# Access Compliance Report

### (Curb Ramps)

Intersection ID: 50464	Main Street: LENOX_POINTE_DR	Cross Street: SANDY_PORTER_RD	Location: NW
ADA ID: 8C6F2BEF603E	Ramp Type: Perp	Initial Pass/Fail: Pass	Overall Compliance: No
		Severity Score: 0

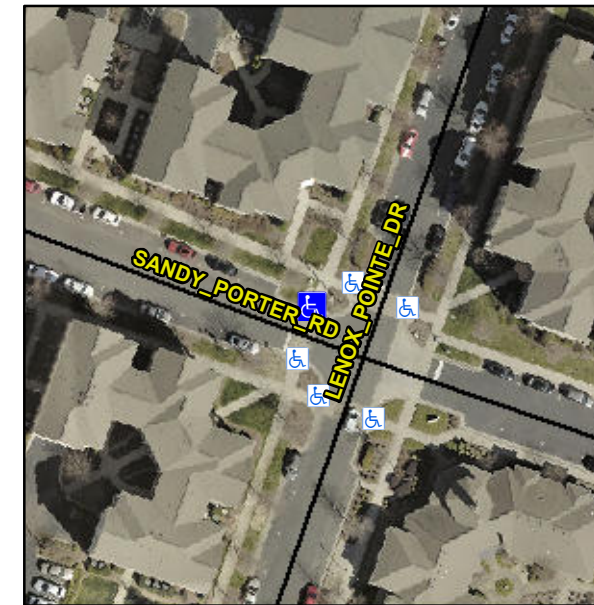
**Not Found, R304.2.2-Perp, R304.3.2-Para**

Compliance	Description	Data	Compliance	Description	Data
N/A	Ramp Length (in)	68.5	Yes	Ramp Slope (%)	8.1
Yes	Ramp Width (in)	48.0	Yes	Ramp XSlope (%)	0.3
N/A	Flare Type LT	Sloped	N/A	Flare Type RT	N/A
N/A	Flare Slope LT (%)	7.9	N/A	Flare Slope RT (%)	3.9
N/A	Flare Traversable LT?	No	N/A	Flare Traversable RT?	No
Yes	Landing Length (in)	60.0	Yes	DWS Provided?	Yes
Yes	Landing Width (in)	71.0	Yes	DWS Contrast?	Yes
No	Landing Slope (%)	3.8	Yes	DWS Length (in)	24.0
Yes	Landing X Slope (%)	0.6	Yes	DWS Full Width?	Yes
N/A	Landing Curb? (Y/N)	No	Yes	DWS Offset (in)	0.0
N/A	Shared Landing?	No			
Yes	Gutter Ponding?	No	Yes	Gutter Slope (%)	3.2
Yes	Gutter Lip Ht (in)	0.0	Yes	Gutter X Slope (%)	0.1
N/A	Painted X Walk1?	Yes	N/A	Painted X Walk2?	N/A
	X Walk 1 Direction	To S		X Walk 2 Direction	N/A
N/A	X Walk 1 Width (in)	144.0	N/A	X Walk 2 Width (in)	N/A
	X Walk 1 Slope (%)	1.3		X Walk 2 Slope (%)	N/A
	X Walk 1 X Slope (%)	0.5		X Walk 2 X Slope (%)	N/A

**Remove & Replace Entire Ramp.**
